SND TP Questions/Comments (February 2021)

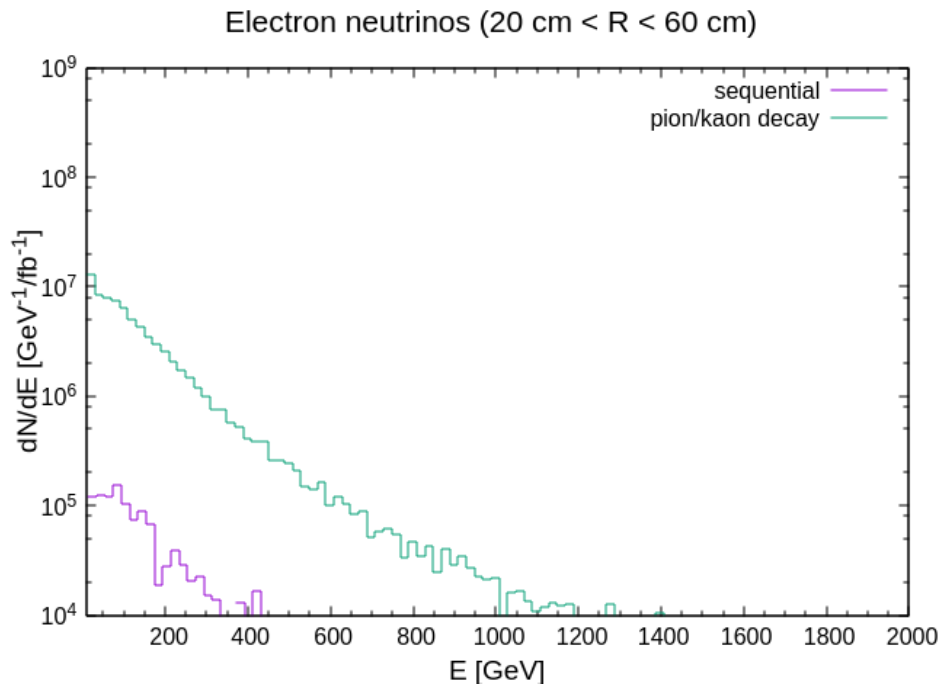
1. Page 8: "HERA studied the reaction $ep \rightarrow \nu_e X, \dots$ ". Several comments about this:

a. This refers to a 1994 paper, and much more precise measurements of the CC interaction were made later, so it's unfair to quote a 30% precision from 14 events. At the end, the CC cross section measurements at HERA relied on thousands of events, leading to precision dominated by systematics, at the level of few% (2-3%).

Thanks for noticing that. We will rephrase it and refer to the most recent paper.

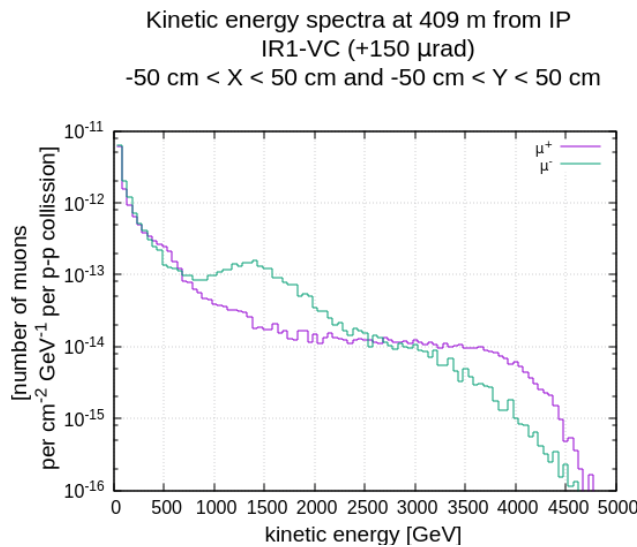
2. Page 10: can you be more explicit what you mean by "electron neutrinos ... from charmed-hadron decays" - do you include only the neutrinos from the prompt D decay, or also from the sequential $D \rightarrow K \rightarrow \nu_e$ decay (which although smaller, is not negligible). Do you count these as from charm or K in your simulation book-keeping, and does this affect your statements about measuring the charm cross-section or (ν_e/ν_τ) flavour universality?

In the TP simulation, neutrinos from the sequential decay are counted as from K. We have now tagged these cases and it turns out that the contribution of $D \rightarrow K \rightarrow \nu_e$ decay amounts to about 1.5% of the kaon component we had subtracted. This is shown in the plot below, based on DPMJET-Fluka full simulation. Therefore we believe its effect is negligible.

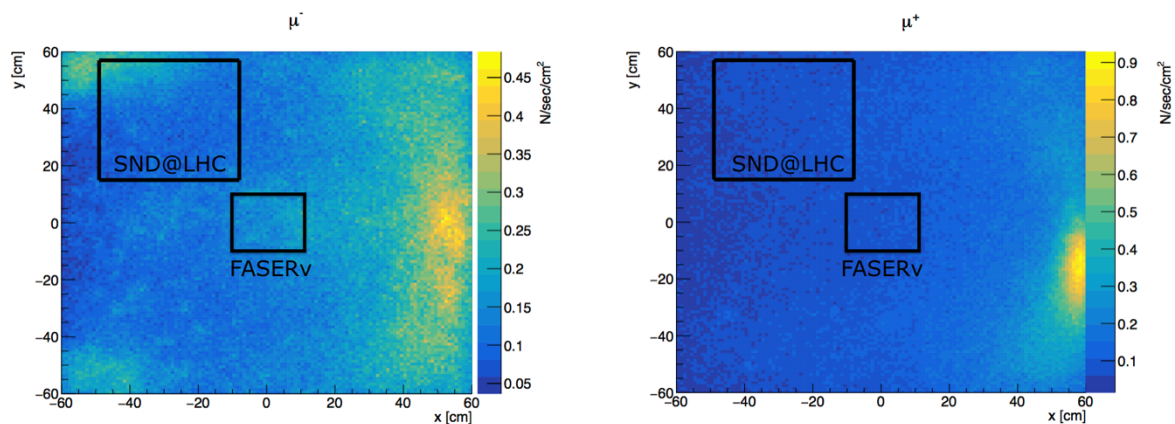
5. Page 21: We did not see the final explanation for the structure of Figure 10 and the difference between positive and negative muons - can you expand on that?

The difference between positive and negative muons is related to the effect of the magnetic field of the accelerator elements on their own and their parents' trajectories. The low energy component of the spectrum (up to about 600 GeV) is dominated by secondaries: this results in an equal amount of positively and negatively charged muons. At higher energies, the drop of the positive muon spectrum shows the effect of the quadrupoles and, mostly, of the dipole

at around 60-70m from the IP which produces a large depletion of events in the quarter where the detector is located. This is clearly seen in the comparison between Figure 10 and the plot below (all quarters).

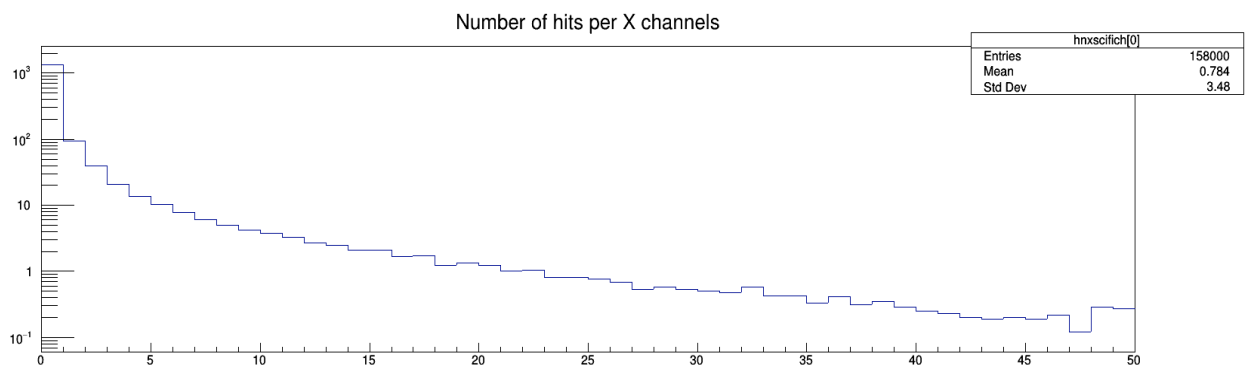
3. Page 39: The heat dissipation into the closed volume is not quite clear. Here it would be

helpful to clearly specify the number of components for a SciFi station: How many mats, how many boards per mat, which power per board, which part of this needs to be cooled away in the volume / which is taken out by water cooling of the boards?

The power dissipation is dominated by the FE chip, water cooling is provided to evacuate this heat. The remaining power of 250W is dissipated by the FPGA board and the DAQ boards power supply (8W/board with 31 boards inside the neutron shielded volume)

Figure 1: Ratio normalized with the bin at $4 < \eta < 4.5$ at 13 TeV.

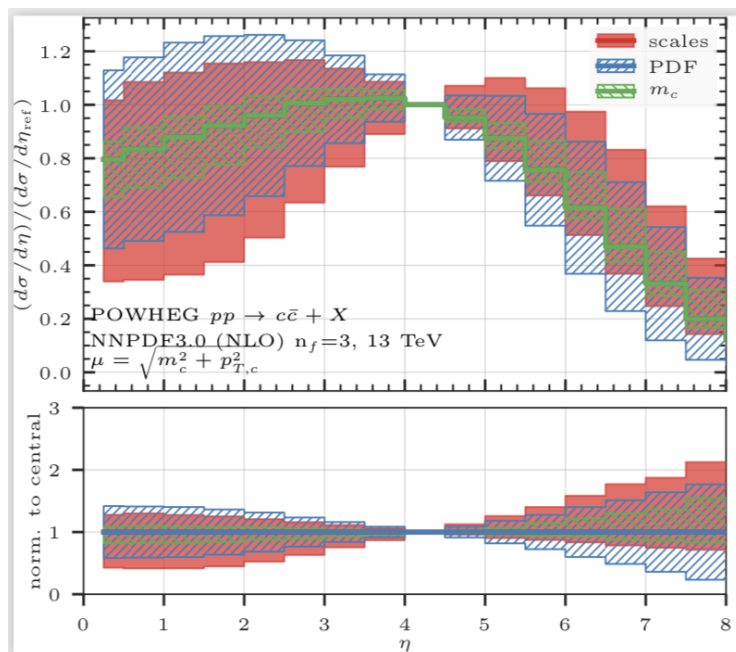
1. Page 87: Although the analysis you cite involved different energies in the numerator and denominator (14 TeV and 7 TeV), can it be done with a common energy (14 TeV) in both? Might this, in fact, reduce further the scale and mass systematics, and therefore enhance the PDF dependence?

Taking a common energy in the cross section ratio would indeed reduce the scale and mass uncertainties. However, at the same time, it also considerably reduces the pdf uncertainty. This is shown in the plot below and it can be traced to the fact that the x values probed in the numerator and in the denominator are closer in the second case, thus enhancing the correlation.
